PD Signature requirements v200

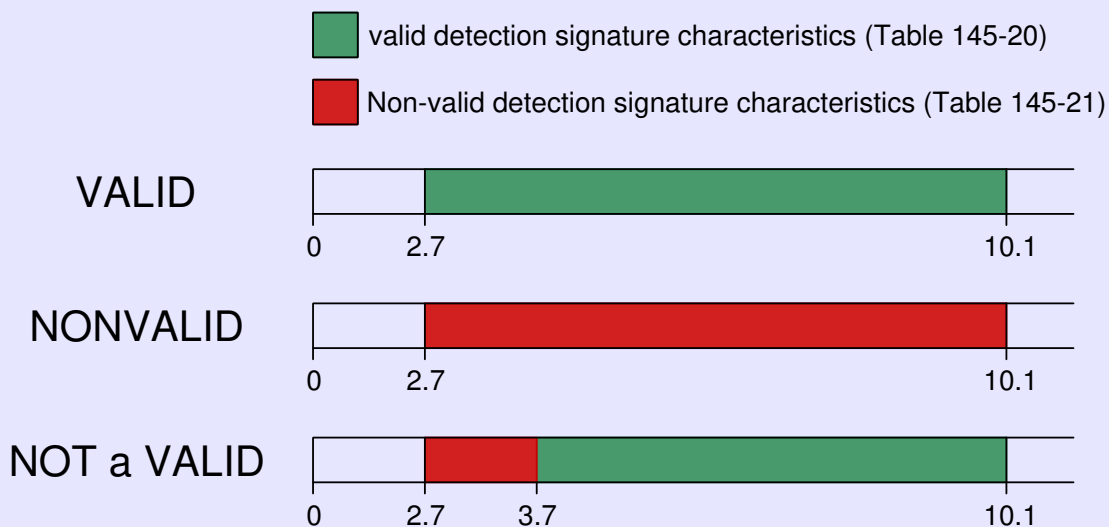
What is the problem?

The current text says that a PD shall show an invalid detection signature on a Mode, when a voltage between 10.1 and 57 volt is applied to the other mode. During connection check, the PSE will apply only voltages *less* than 10.1 volt to the other mode. Thus, this requirement does not apply in the voltage range where we need it to apply.

The new requirement (paraphrased) is that: “The PD shall not present a valid detection signature on a Mode when a voltage between 3.7 and 10.1 volt is applied to the other Mode”.

When 3.7 volt is applied as the corrupting voltage, the PD is assured to have a non-valid detection signature at least in the range of 2.7 to 3.7 volt. Because it no longer meets the requirements for a valid detection signature, it now meets “shall not present a valid detection signature”.
